Application reference: PAN-000849

Applicant: Radnor Hills Mineral Water Company Ltd

Facility: Radnor Hills, Heartsease, Knighton, Powys, LD7 1LU

We are responding to your Schedule 5 notice dated 20th June 2017 on behalf of Radnor Hills Mineral Water Company Ltd.

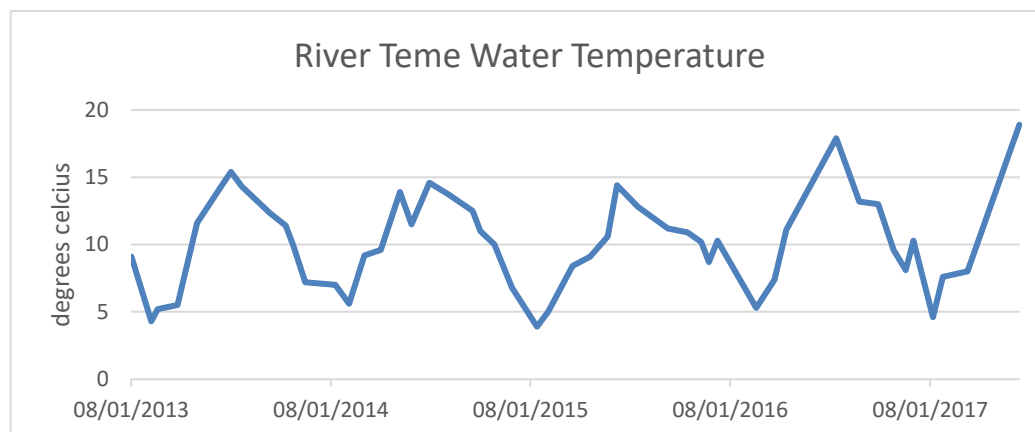
A question was raised in the Schedule 5 regarding the nutrients and chemical additives that are to be added to the effluent treatment plant, and whether any of these will be present in the final discharge.

Aquabio provided the following details on nutrients and cleaning chemicals for the process:

It has been confirmed by Aquabio that any added nutrients and chemicals to the process will be removed by the MBR and will therefore not be present in the discharge.
